**RFI**

**RFI #:** 161  
**Date:** 6/25/2012  
**Job:** EB-02 Keller Springs Lofts  
**Phone:** 877-777-5115

**Subject:** Electrical Outlets Moved for Code

**RFI #:** 118  
**Date:** 5/16/2012  
**Job:** EB-02 Keller Springs Lofts  
**Phone:** 877-777-5115

**Drawing:** E2.1, E2.2, E2.3, E2.4, E2.5, E2.7, E2.9 & E2.11  
**Cost Impact:** None  
**Spec Section:**  
**Schedule Impact:** None

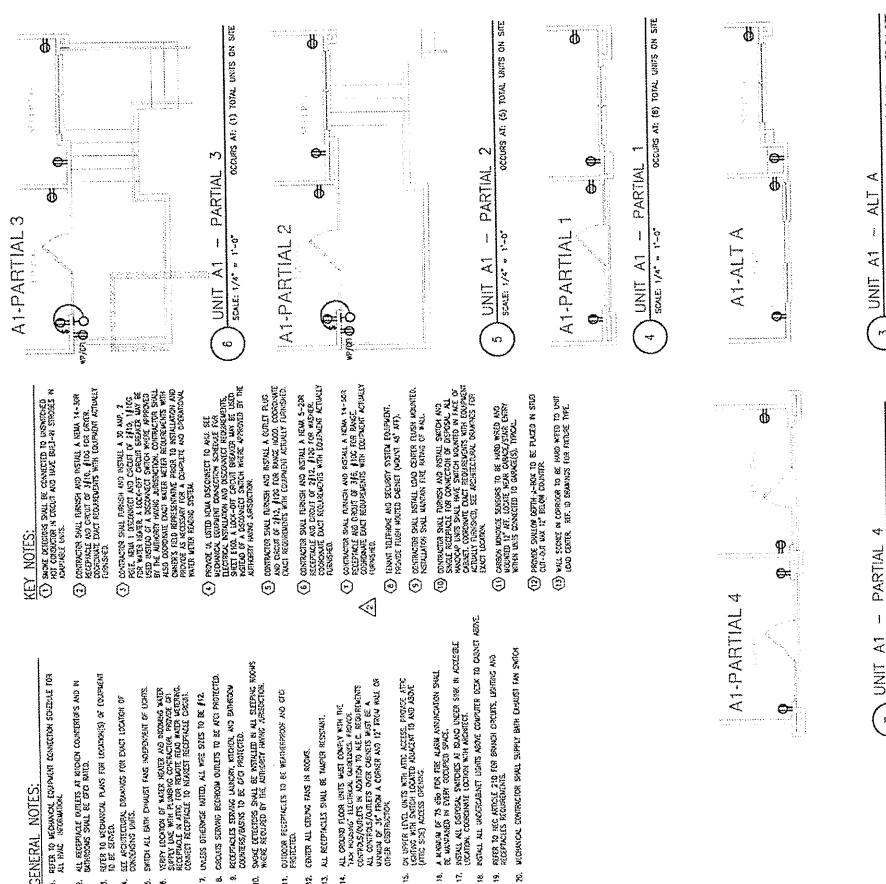
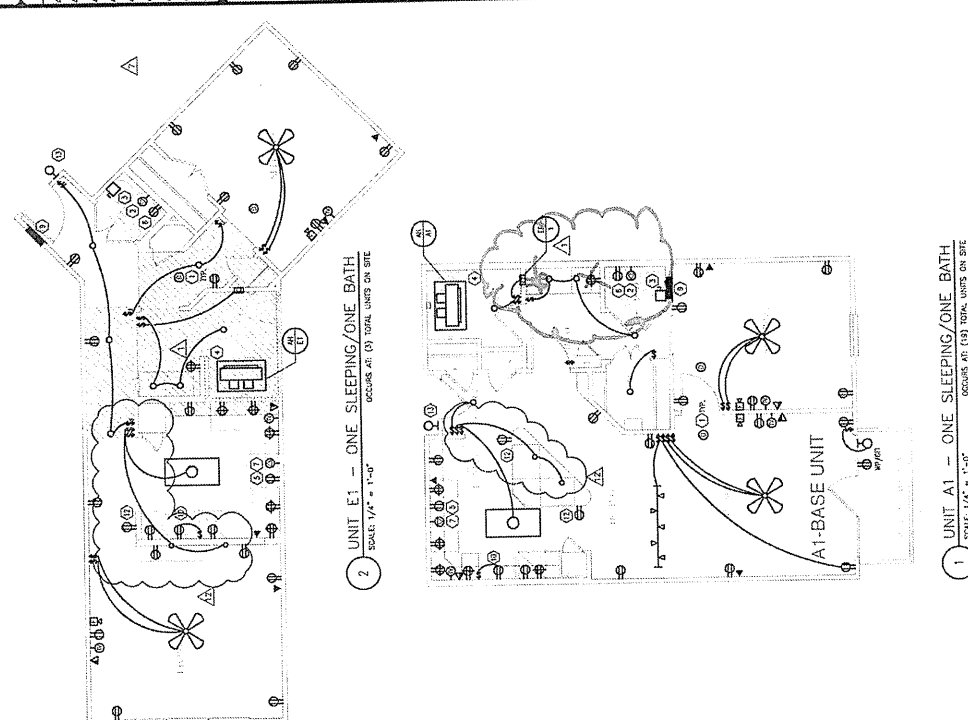
**Request:** **Date Required: 5/23/2012**  
 1. Patio receptacles will either not fit or there will probably be too much framing for the rough in boxes to fit in the following units: A1, A3 ALT-D, A3 ALT-E, A4, B1, B1-L, B1-K, B2C-ALT1 and A1-HC.  
 2. None of the pendant lights are shown on drawings.  
 3. Switch for bath exhaust fan in A2-SP and A1-HC are not shown.  
 4. Switch for living room ceiling fan light is not shown for A2 and A3 units.  
 5. Living room switched outlet is not shown in the E1, A2SP and B3 units.

**Response:**  
 1. Per NEC 210.52, a receptacle must be placed within the perimeter of the balcony or deck. If space is not available to mount recessed, a surface mount receptacle may be used.  
 2. Pendant lights shall be shown on the upcoming clubhouse revisions issue.  
 3. Locate bath exhaust fan for the A1-HC unit next to the three way switch in the bathroom on the common wall with the kitchen. For the A2-SP unit locate the bath exhaust switch next to the switch for the light over the toilet.  
 4. locate switch for ceiling fan light next to switch for ceiling fan.  
 5. All units should have switched light in the ceiling fan, therefore the switched receptacle is not required, unless owner's desire is to keep it.
